Access Compliance Report Public Rights-of-Way (Curb Ramps)

Main Street: **MERCANTILE_WAY** Cross Street: **N/A** Location: **S**

ADA ID: **RPRK211102113902** Ramp Type: **Type 4 - Parallel** Initial Pass/Fail: **Fail** Overall Compliance: **No** Severity Score: **2**

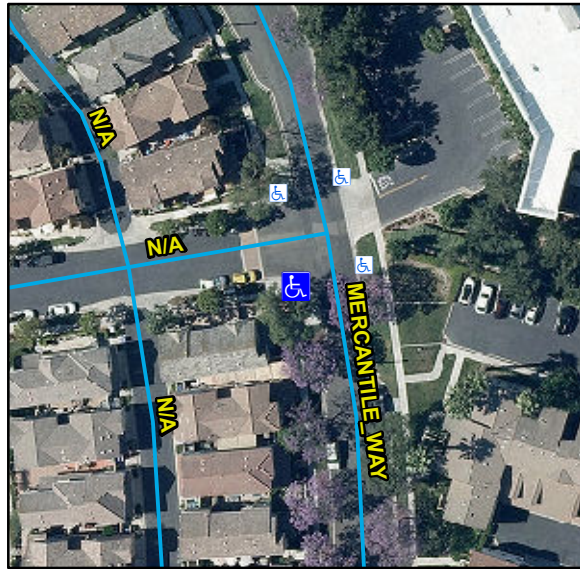
R304.2.2, R204.3, R304.5.3, STD 1115

Remove & Replace Curb Ramp With Two New Directional Ramps or Equivalent.
